Suite 217-
ORIGINAL (SALES)
(INVENTORY SUITE)

SAG HARBOUR: 217
- MOVE FRONT DOOR (FOR 6" WALL BEHIND WASHER/ DRYER)

Sag Harbor

Kitchen

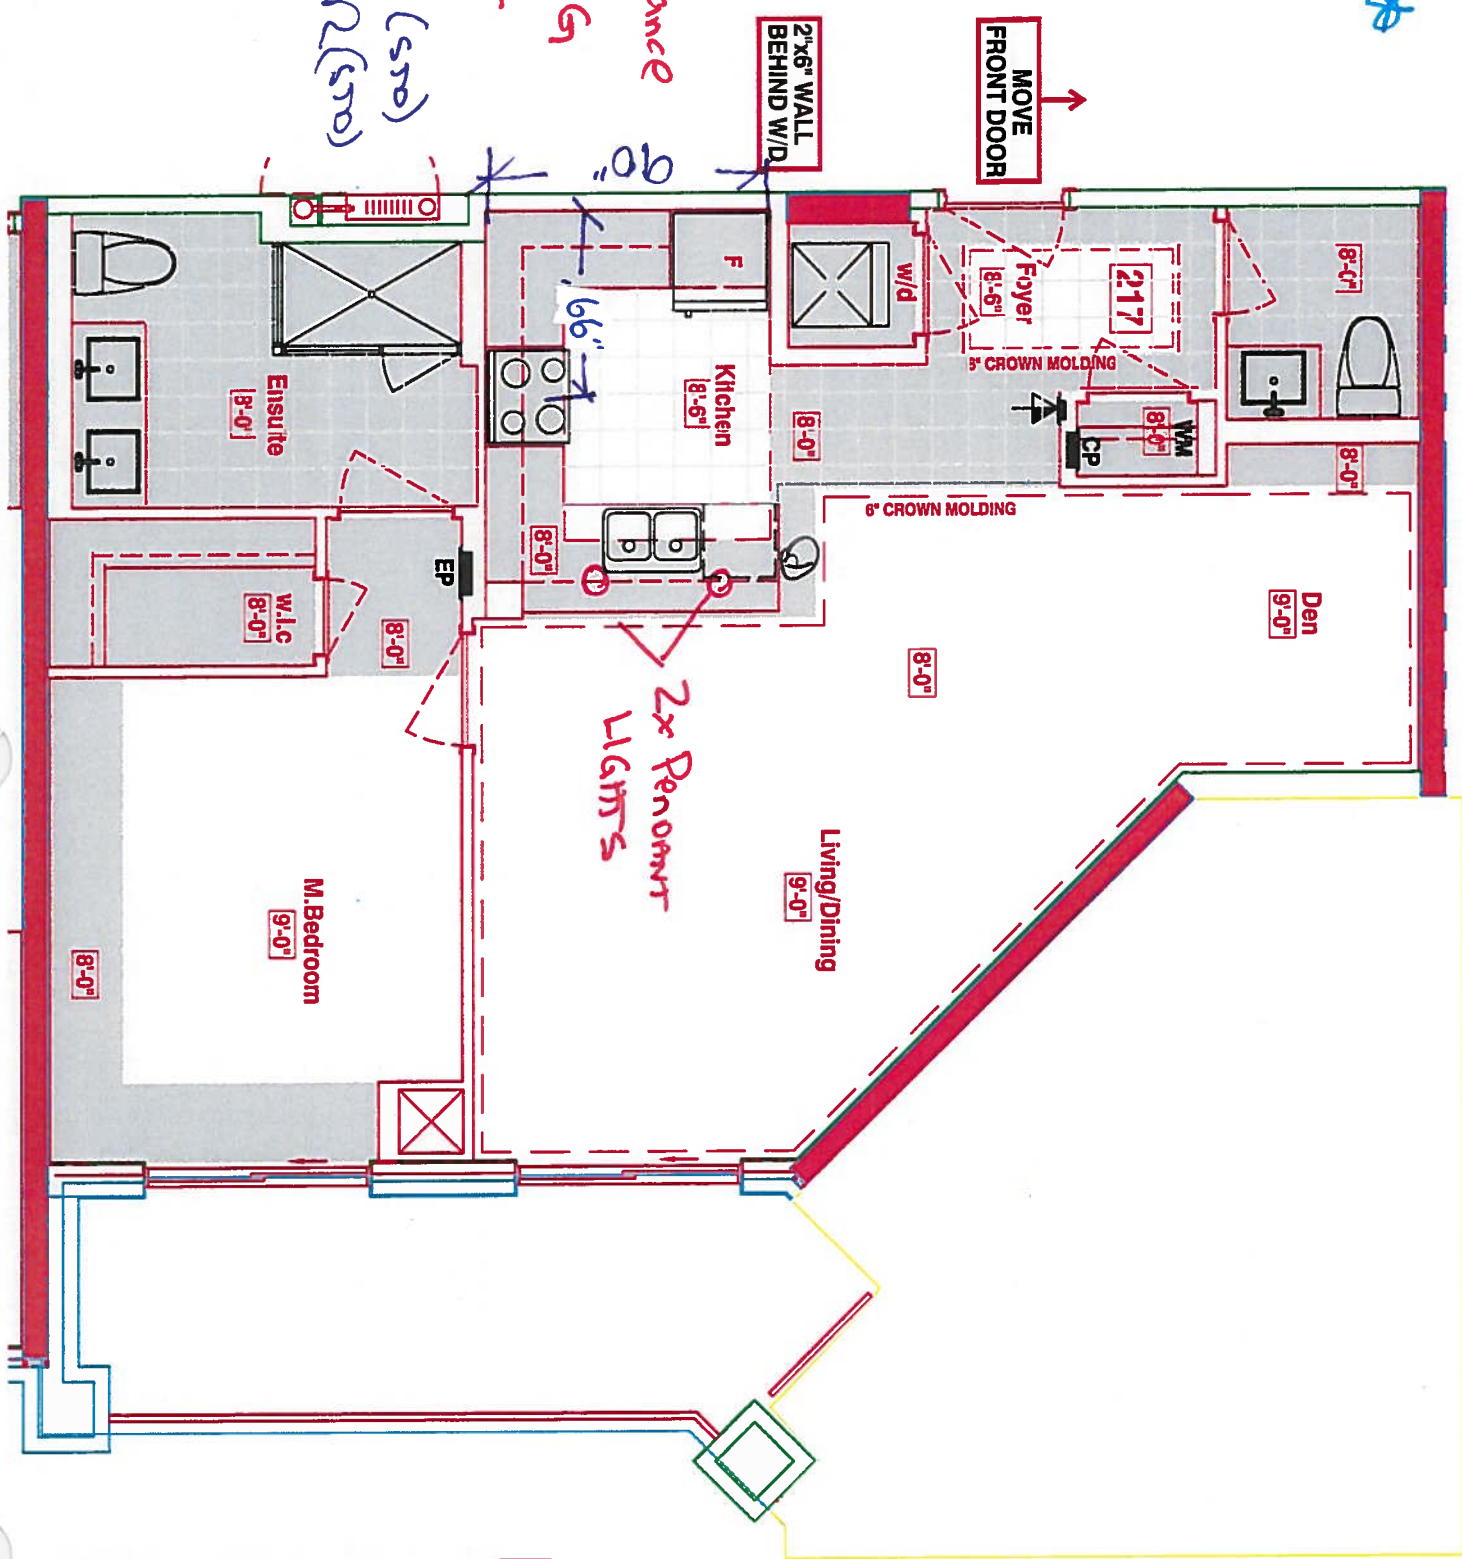
*Front Door move *
Due to Laundry Room
Kitchen size .

6" WALL
BEHIND W/D
ELIMINATE JOG
AT FRIDGE WALL
